Designed: 2/25/15 TIER 3 PHASE 3 M.P.177.00 TO M.P.160.00 HSR SCOPE CHANGE Rec#: WO#:22820 IS: MWK/ /NST/JVJ	Designed: 08/21/12 TIER 3 PHASE 3 M.P.177.00 TO M.P.160.00 UPGRADE XINGS AND CP'S FOR HIGH SPEED RAIL Rec#: WO#:22820 IS: /MWK /NST/MJF	CIRCUIT MODIFICATIONS ARE NOT TO BE MADE WITHOUT AUTHORITY FROM THE OFFICE OF SIGNAL DESIGN	Date: 08/21/12 Des: NST Chk: MWK AFE: 22820	UNION PACIFIC RAILROAD WILLIAMSVILLE, ILLINOIS MAIN STREET SPRINGFIELD SUBDIVISION Office of AVP Engineering - Signal Omaha, Nebraska	Sh.: 14C DOT 294275U MP: 173.02 ID: CSL17302.14CX

UNION PACIFIC RAILROAD
WILLIAMSVILLE, ILLINOIS
MAIN STREET
SPRINGFIELD SUBDIVISION
Office of AVP Engineering - Signal Omaha, Nebraska

WILLIAMSVILLE, ILLINOIS
MAIN STREET
M.P.173.00
SPRINGFIELD SUBDIVISION
D.O.T.#294 275U

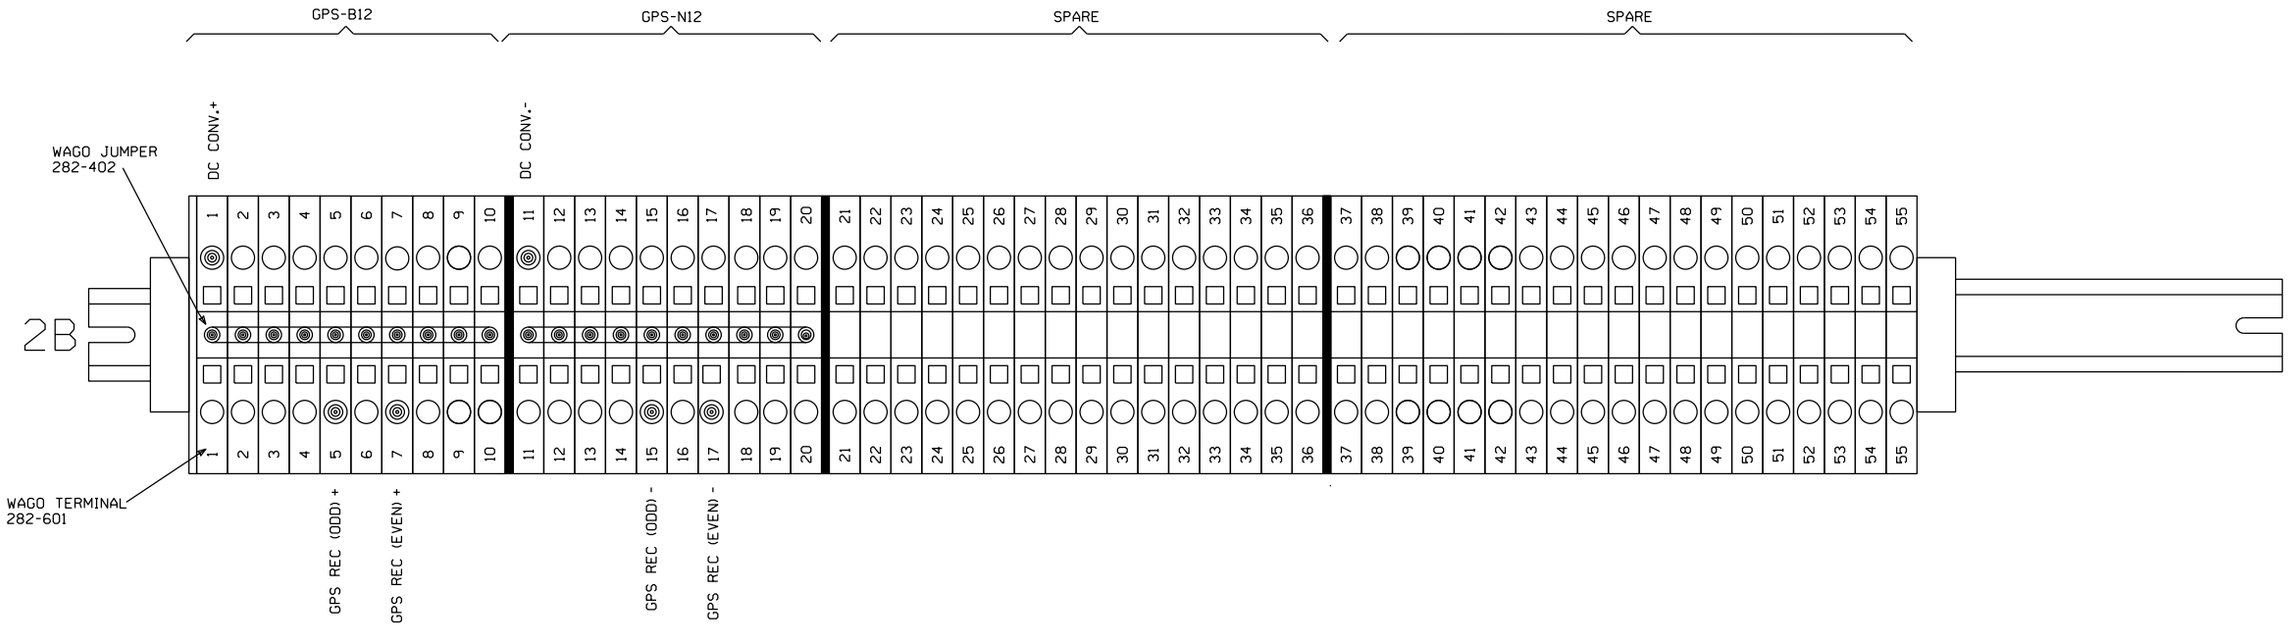
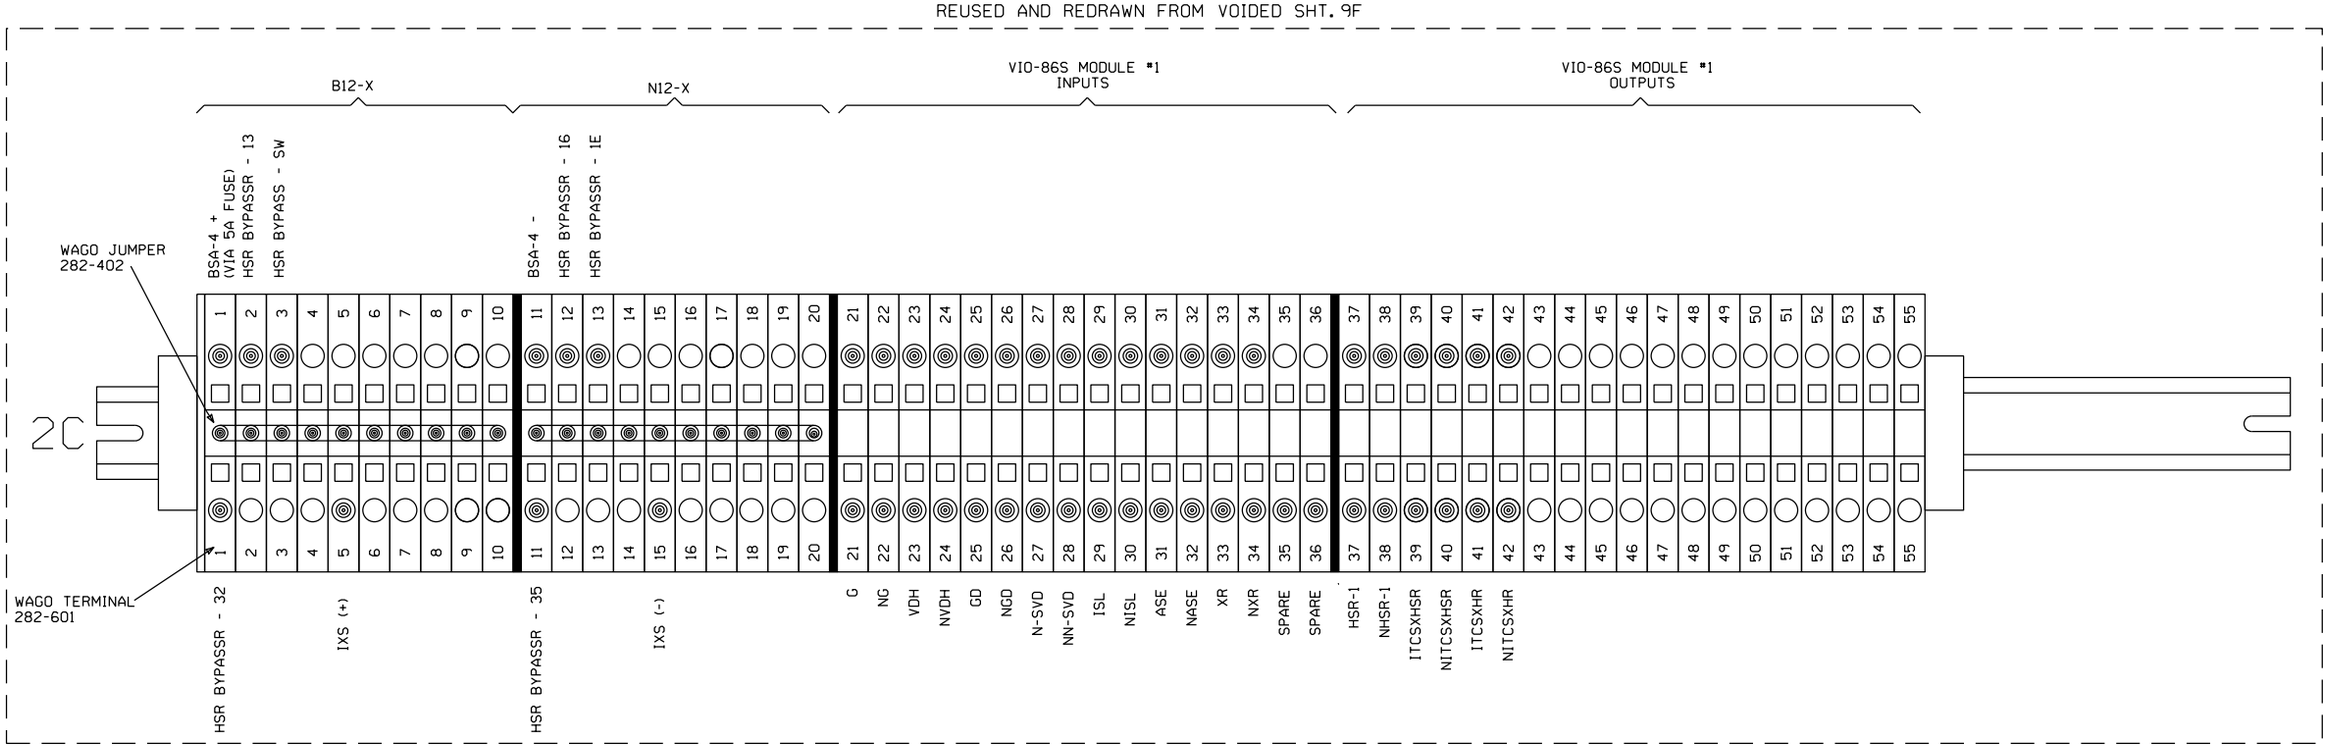
REUSED AND REDRAWN FROM VOIDED SHT. 9F

Sh.:	9F
DOT	294275U
MP:	173.00
ID:	CSL17300.9FX

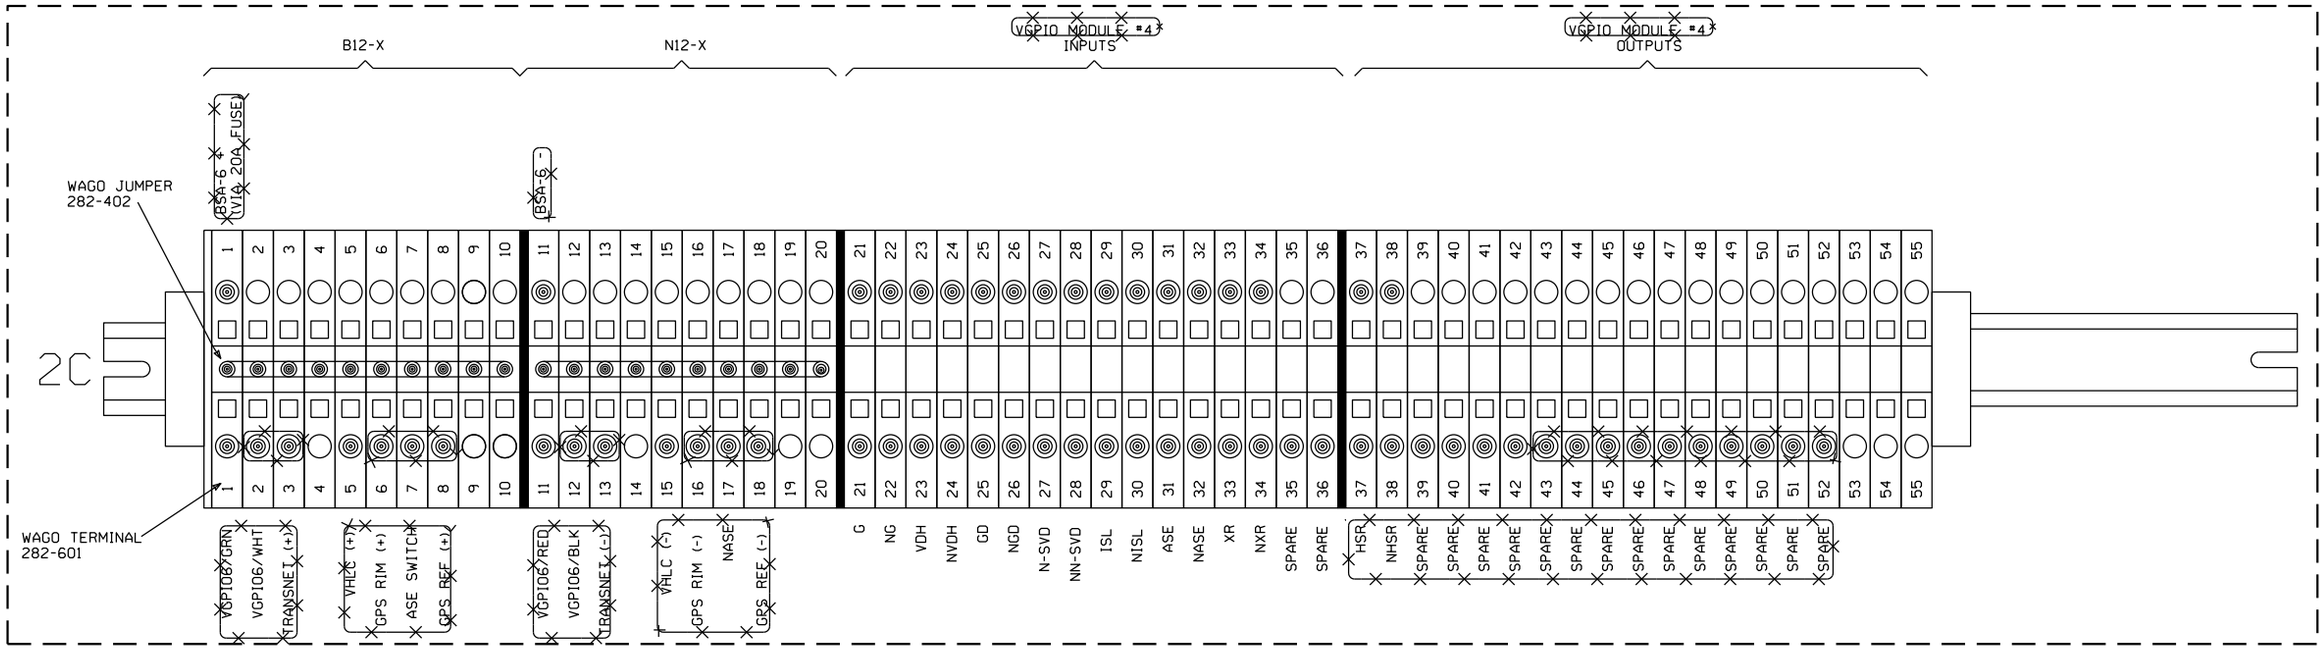
REUSED AND REDRAWN ON NEW SHT.14F

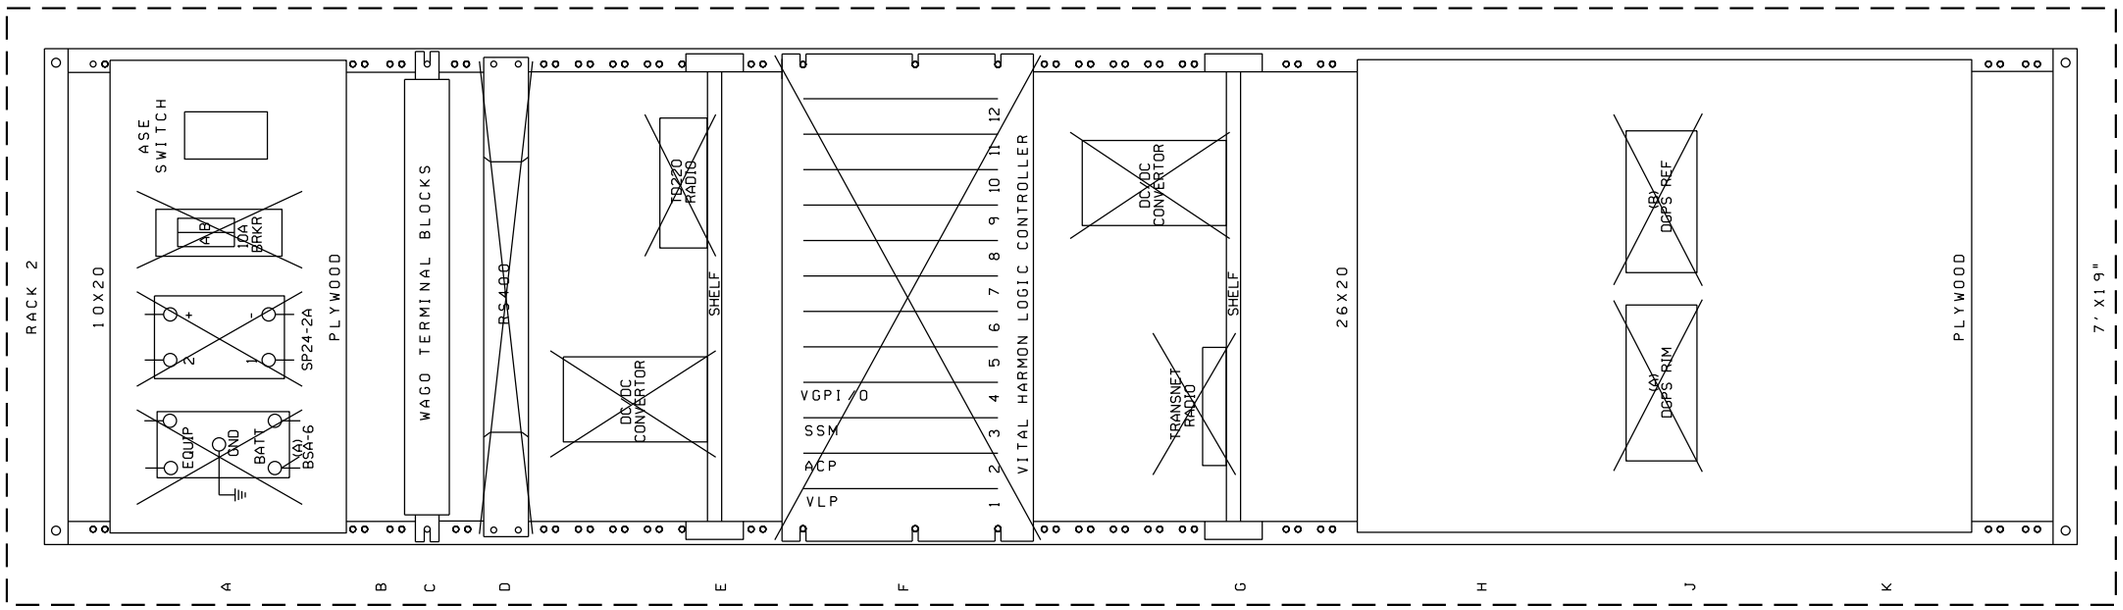
REUSED AND REDRAWN ON NEW SHT.14E
